BACnet Errata
ANSI/ASHRAE STANDARD 135-2016
A Data Communication Protocol for Building Automation and Control Networks

February 5, 2020

This document lists all known *errata* to ANSI/ASHRAE Standard 135-2016 as of the above date. Each entry is cited first by clause, then page number, except where an erratum covers more than one clause. The back page marking identifying the electronic publication of Standard 135-2016 is “Product code: D-86451 6/16”.

Figure 15-5. By Time with a Positive Count

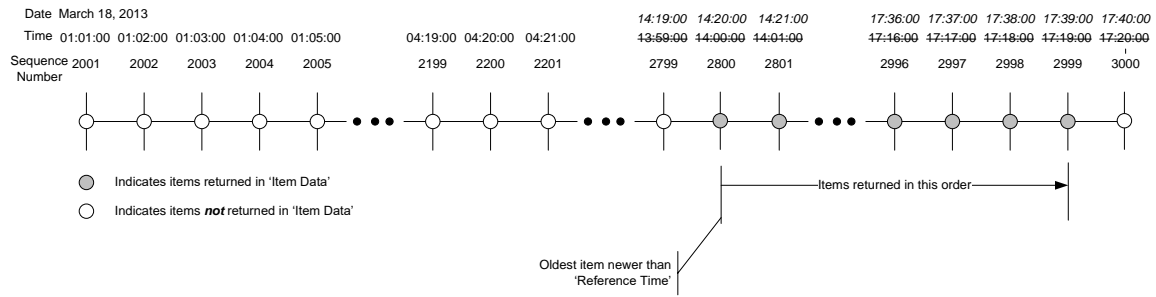
- 37) **Clauses 15.8.1.1.4.3.3, 15.8.1.1.4.3.4, 15.8.1.1.4.3.5**, p. 695, 696: The time scale in the examples is erroneous.

Assume a device contains a list with 1000 items and is capable of returning 200 items in a ReadRange response. The ReadRange service request contains a 'Reference Time' = March 18, 2013, ~~14:19:00~~ *14:19:00* and 'Count' = 300. The resulting ReadRange service response contains 200 items from March 18, 2013, ~~14:20:00~~ *14:20:00* to March 18, 2013,

~~17:19:00~~ 17:39:00 with FIRST_ITEM = FALSE, LAST_ITEM = FALSE, and MORE_ITEMS = TRUE. The 'First Sequence Number' = 2800.
